Annual Evaluation of Groundwater Management by the Delano-Earlimart Irrigation District Groundwater Sustainability Agency

Tule Subbasin | March 2026

Figure 1. DEID Change in Storage Excluding Subsurface Inflows and Outflows, Water Years 1986-1987 through 2023-2024

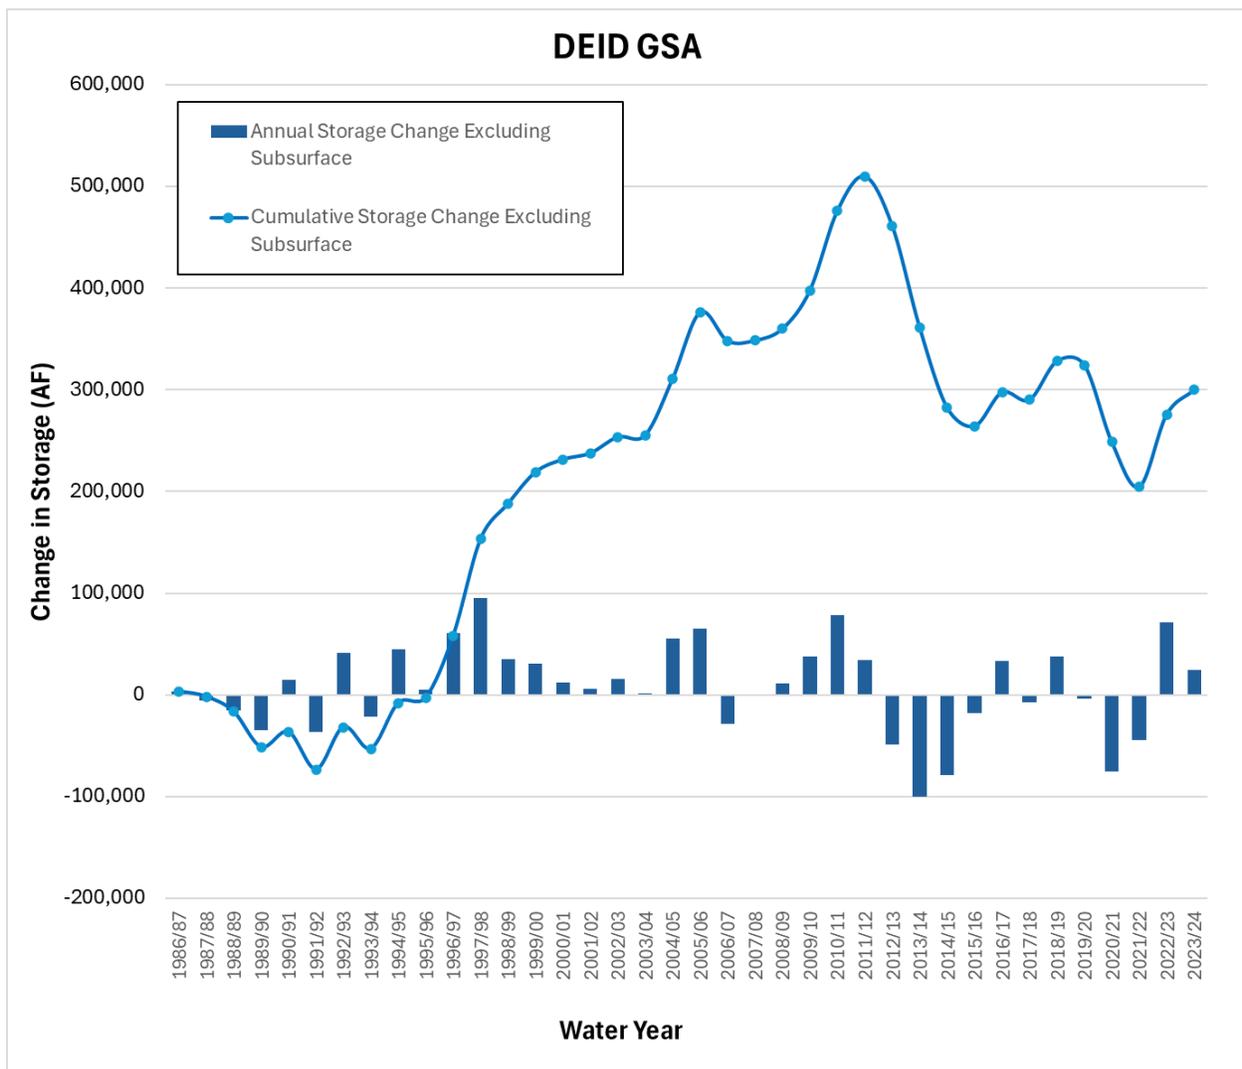
Overall groundwater storage in DEID decreased in most years since approximately WY 2013 but rebounded during wet years so that the overall trend is neutral (balanced) (Quinley, 2025a). For WYs 2020 through 2024, water budgets varied from year to year, likely influenced by hydrologic water year type, surface and groundwater fees, and other factors. These data show that gains in storage in wetter years offset losses in storage in drier years, and the cumulative increase in groundwater in storage since 1987 remains 299,000 AF (see Figure 1).

Even with two significant drought periods (2012-2016 and 2020-2022), average surface water use has increased since WY 2013 (Quinley, 2025c). However, the increase in groundwater pumping since WY 2013 is greater in magnitude than the increase in surface water use, indicating increased groundwater usage and overlapping dry periods may largely be responsible for periods when groundwater storage declines. Despite some declines in groundwater storage subsequent to WY 2013, DEID maintained a net positive account of groundwater in storage of 299,000 AF (Quinley, 2025c).

Figure 2. InSAR data showing cumulative subsidence within DEID from June 2015 to July 2025.

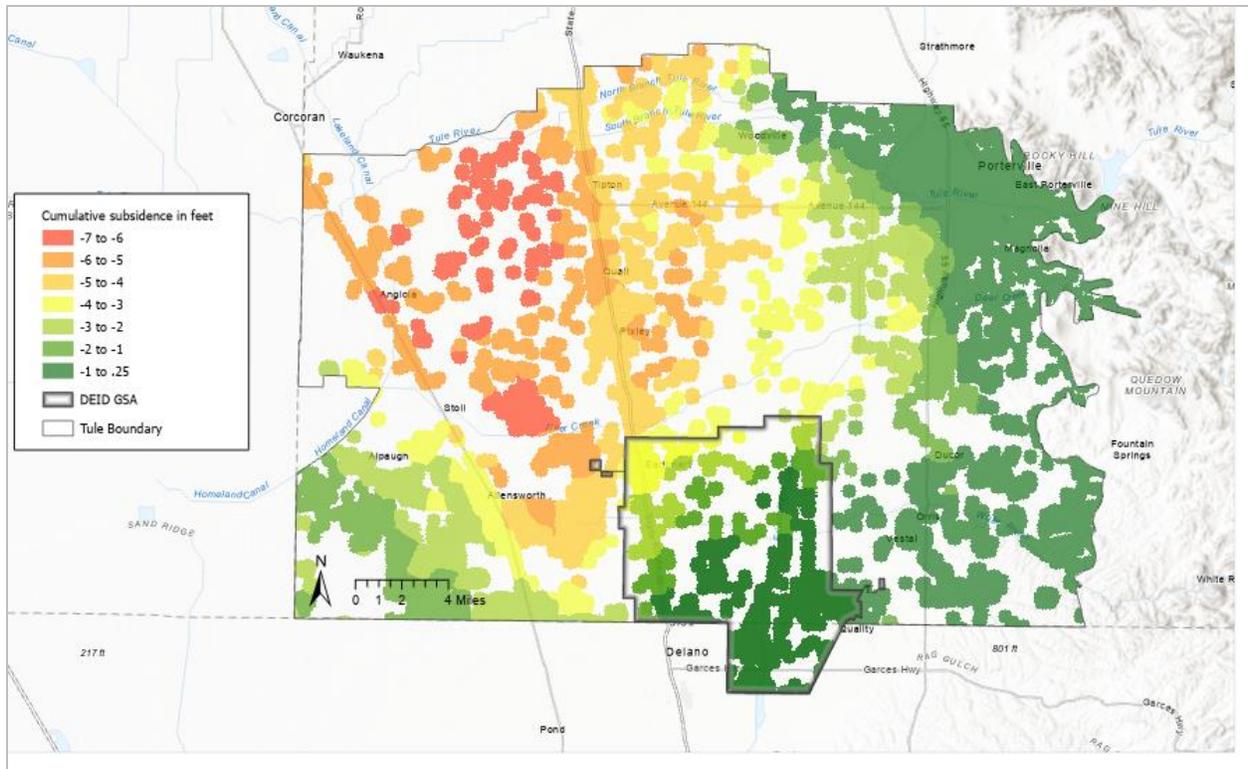
DEID has experienced considerable subsidence (Figure 2) in the decade since the passage of SGMA. Total cumulative subsidence from June 2015 through April 2025 at land subsidence representative monitoring sites (RMSs) ranged from 0.01 to 3.53 ft, with the highest amounts of subsidence in the northern and eastern portion of the GSA. InSAR data (California Department of Water Resources, 2025b) from July 2024 to July 2025 show less than 0.4 feet of subsidence experienced within the GSA.

While DEID experienced considerable subsidence within the last decade, the subsidence may only be partially attributable to pumping in DEID. InSAR data show higher subsidence rates northwest of the GSA, where growers have limited surface water sources and the lower aquifer is more overdrafted. As noted above, DEID’s water budgets indicate that the GSA annually imports and applies enough surface water to generally offset storage losses in dry years.

Figure 3. Image taken from DEID’s 2024 GSP (Figure 0-16) showing model results of subsidence attribution analysis. DEID’s analysis concludes DEID was responsible for less than one foot of subsidence during 1986-2017.

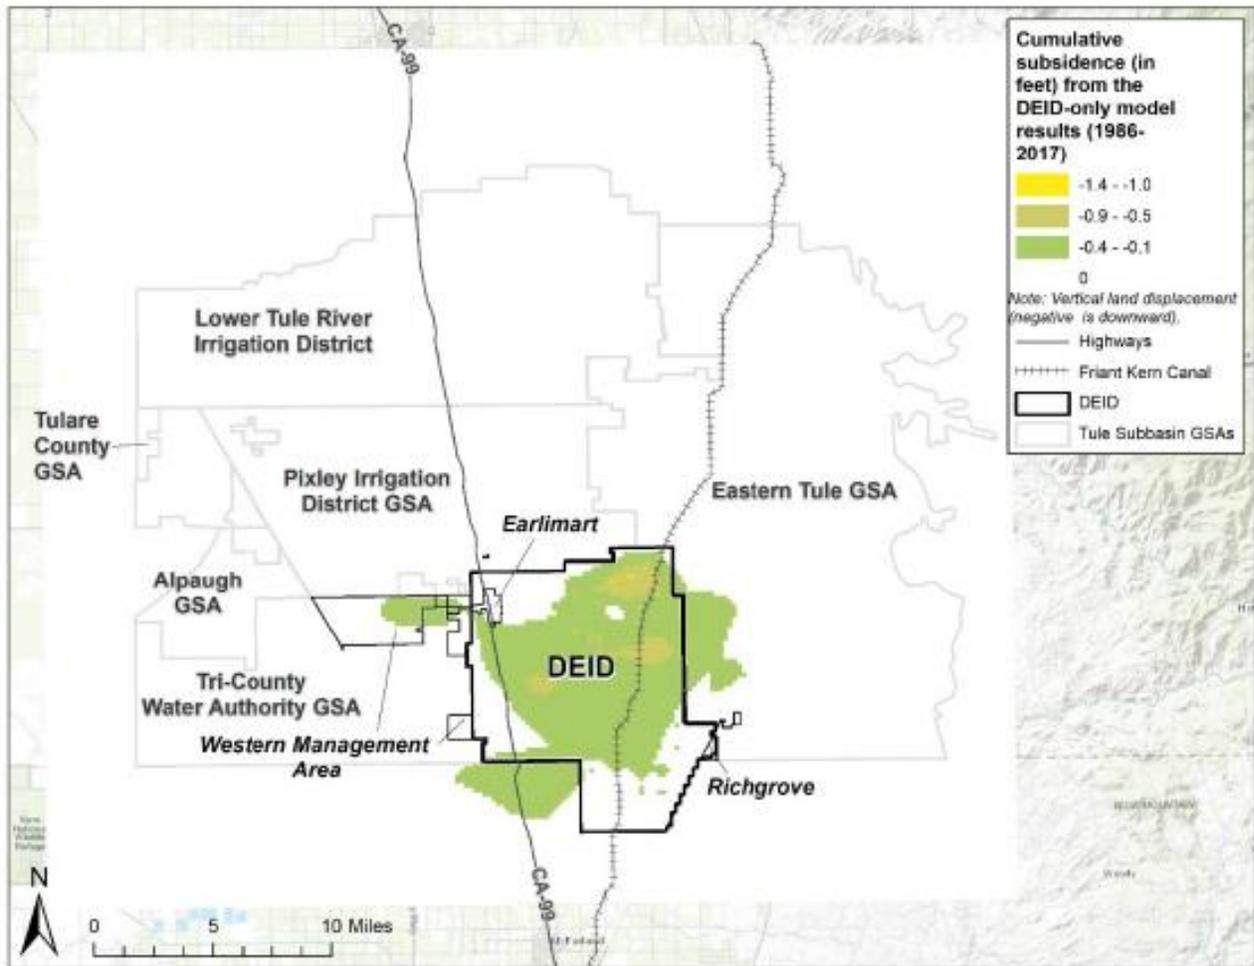
DEID conducted a subsidence attribution analysis to investigate DEID’s contribution to subsidence from 1986 to 2017 (Figure 3). From that analysis, DEID claims approximately 20 feet of the subsidence in the most impacted areas of the GSA was induced by pumping in neighboring GSAs (2024 Draft GSP, p. ES-19). The analysis concluded that less than 1 foot of subsidence was attributed to pumping within the GSA (ibid, p. ES-16).
